Project Details:
Dalgise
Monkstown

Drawing Title:
Proposed Elevations + Sections - Block C

Status	Purpose of Issue	Revision
P01	PLANNING PERMISSION	
MKS-RAU-C-ZZ-DR-AR-200		P02

BLOCK C

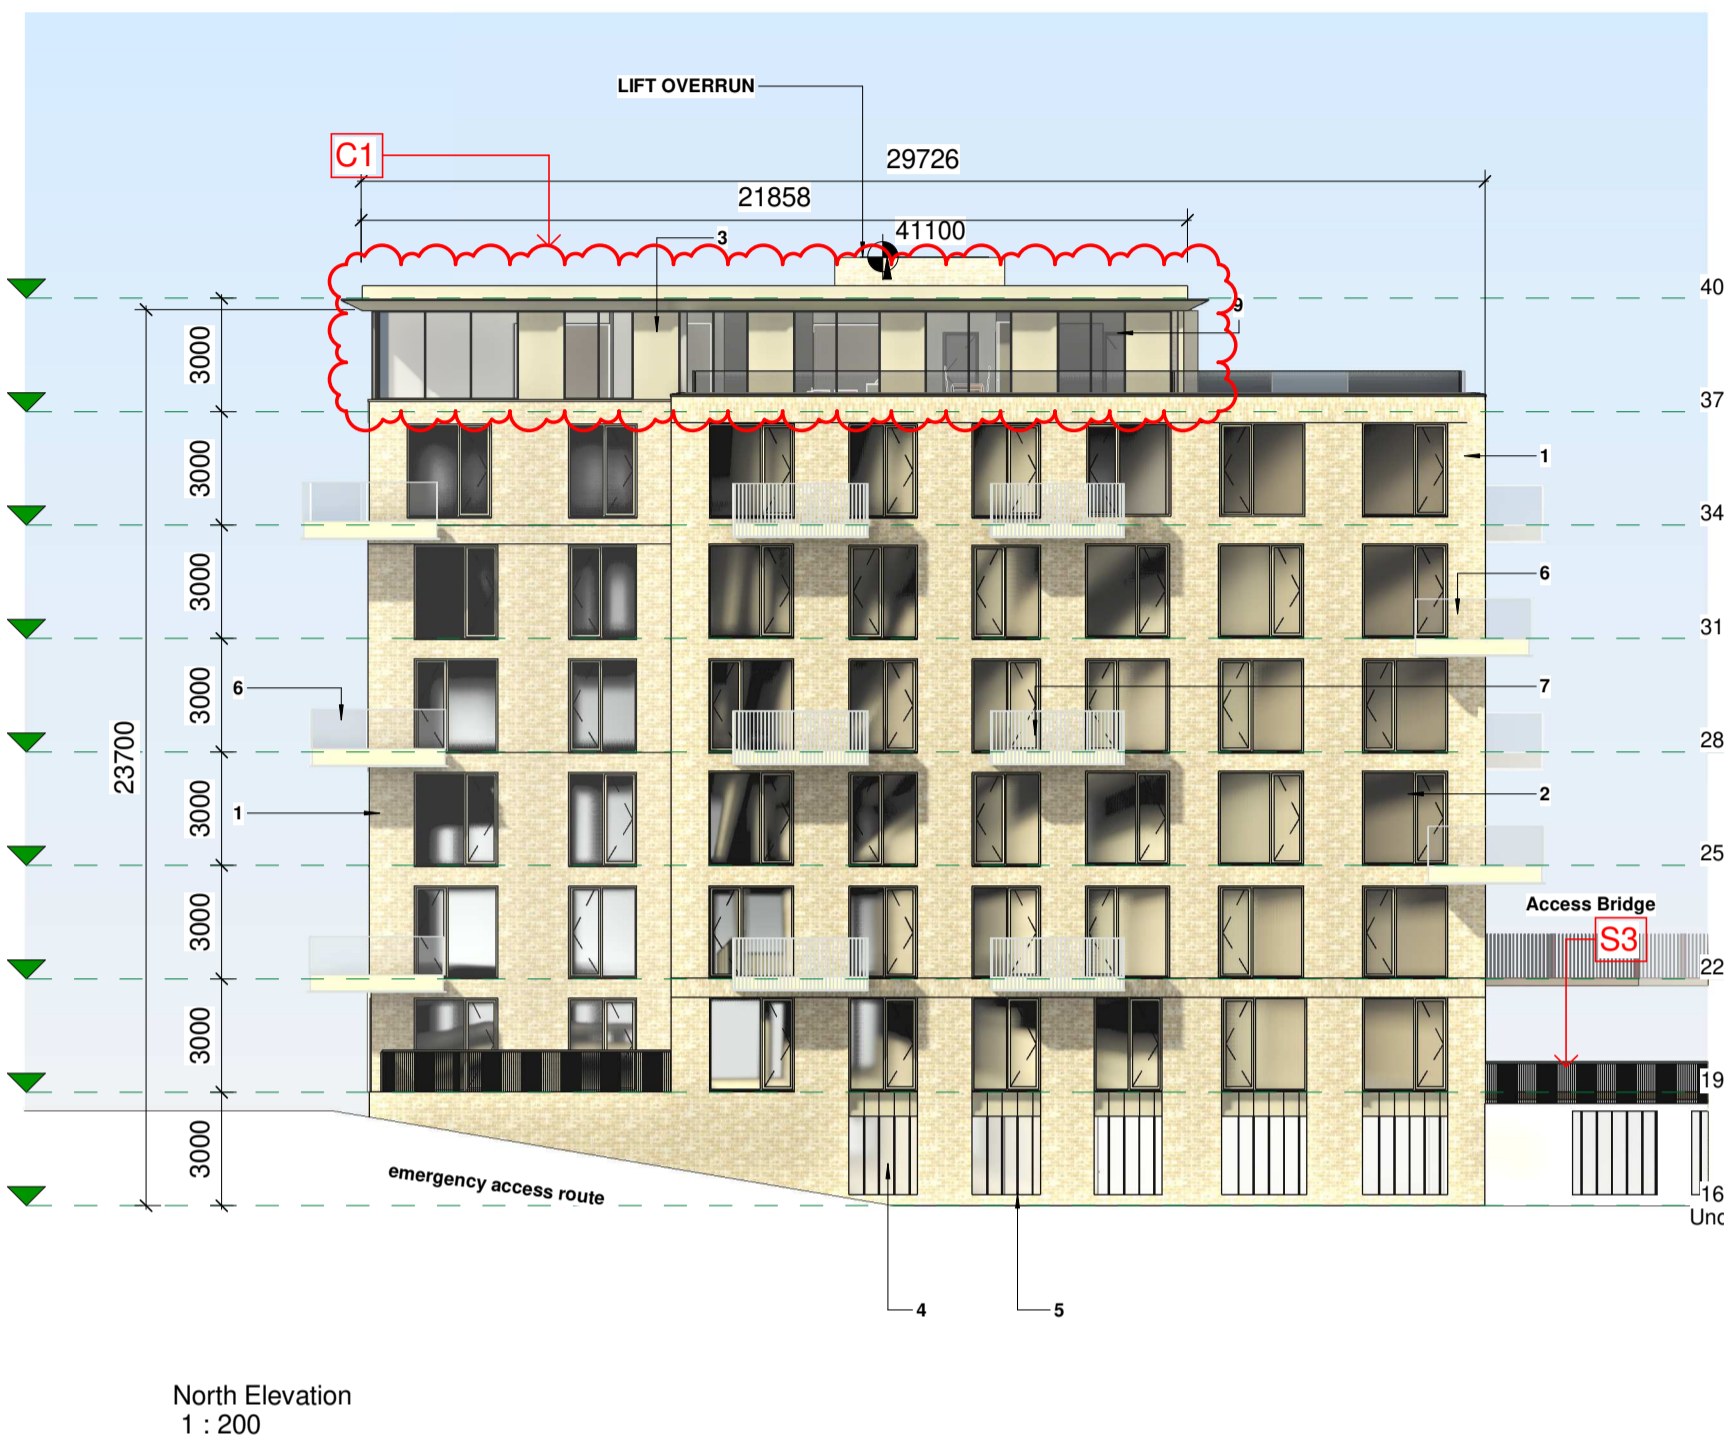
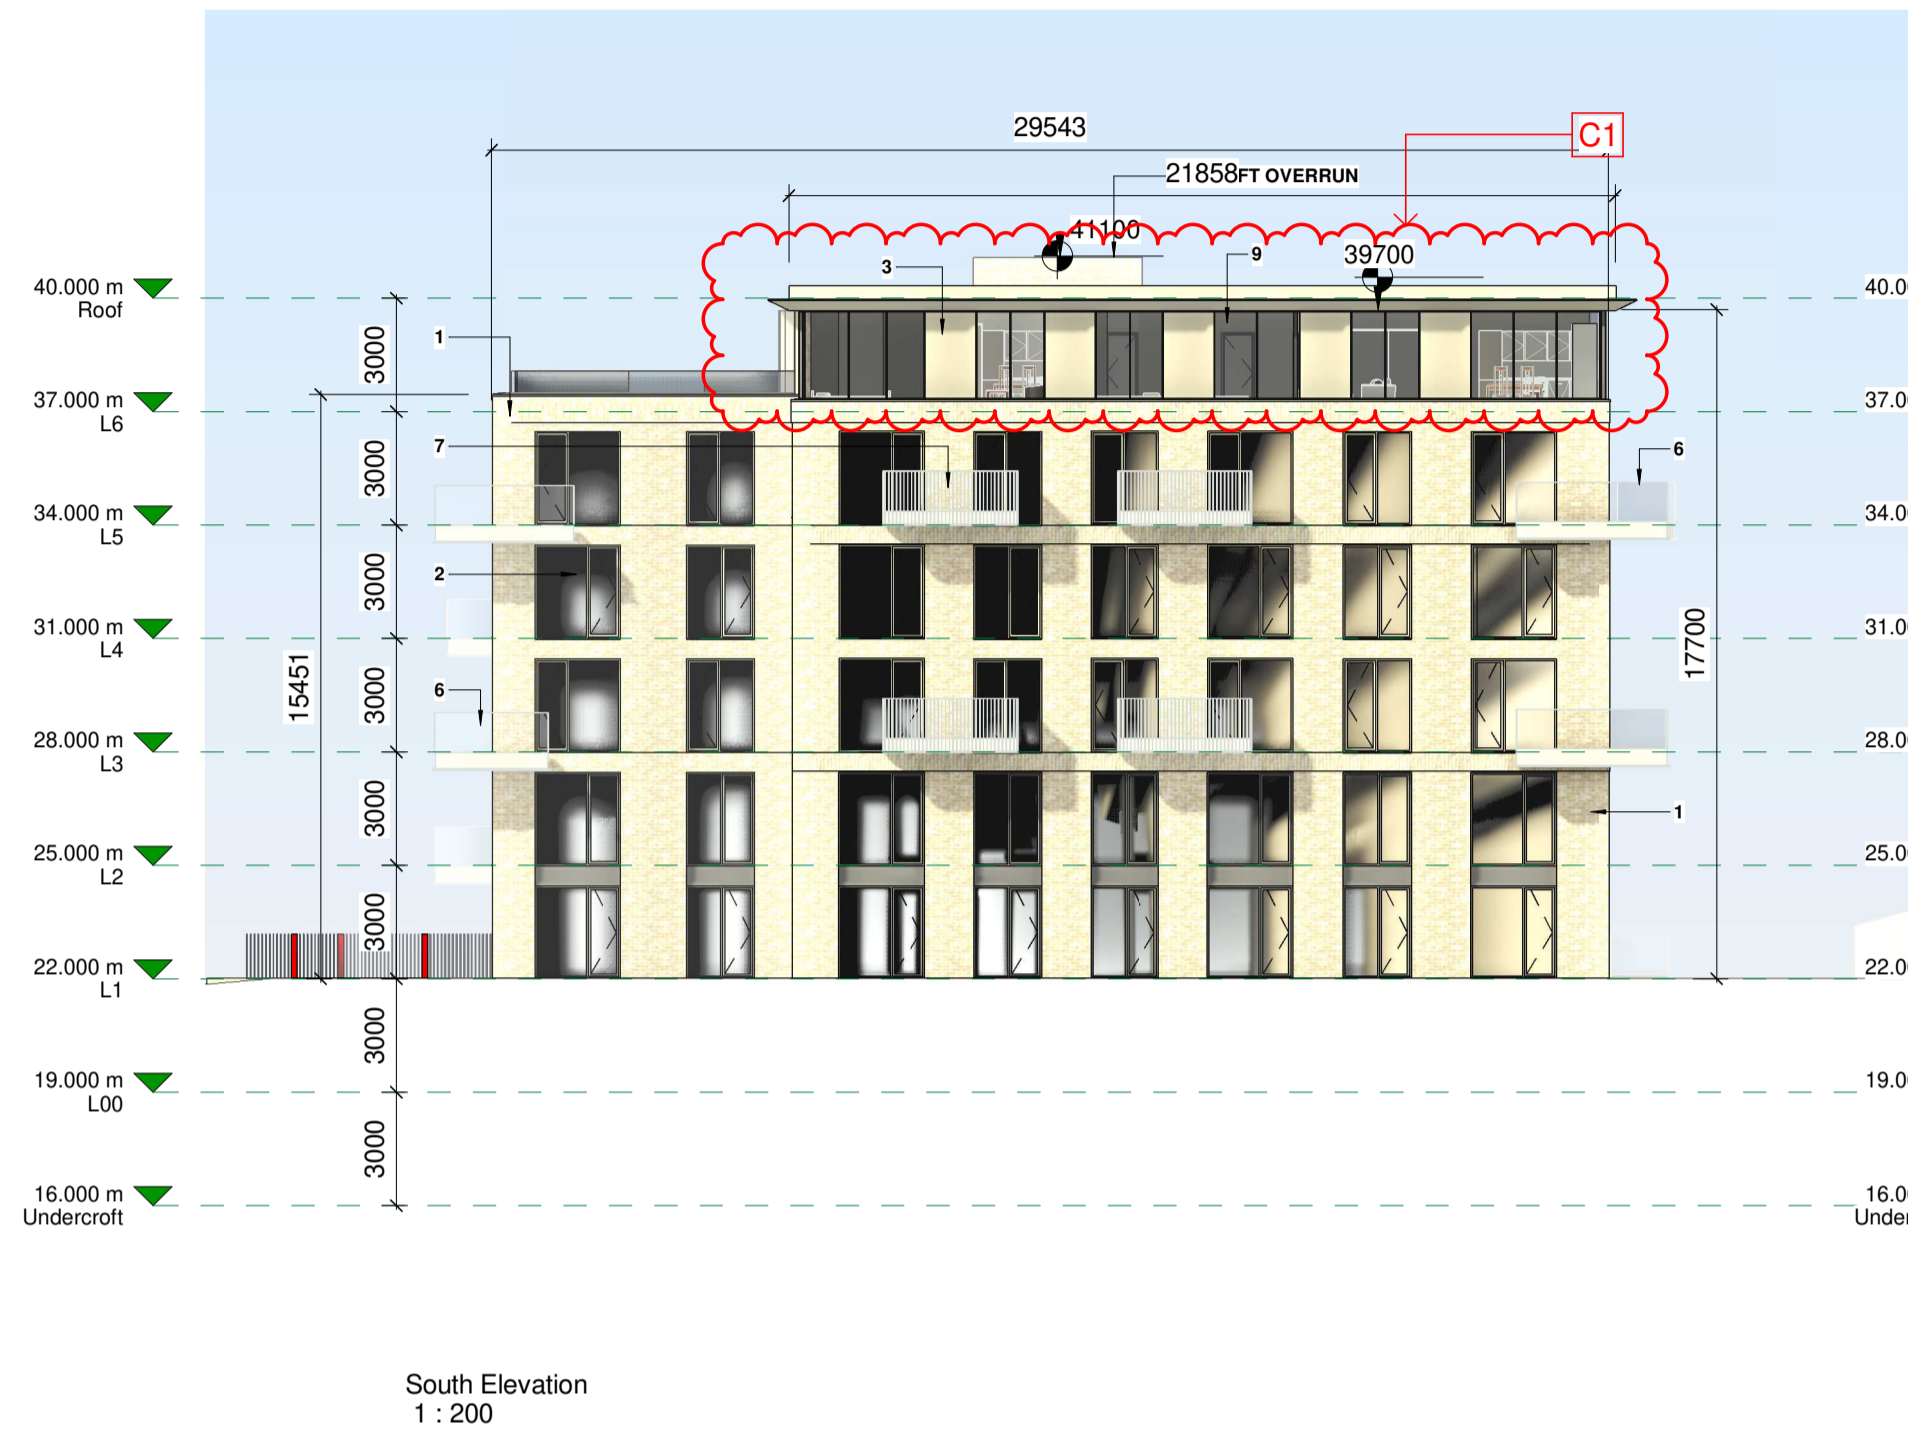
- REVISIONS**
- C1. Tonal change at penthouse level.
 - C2. Brick indent detail added to facade
 - S3. New external amenity space added ground floor between Block B+C.
 - B3. Access route to new amenity space added at Ground level (lwr)
 - B4. Private Balcony added to Apartments B_00_01 and C_00_01 (Refer to HOA for areas)
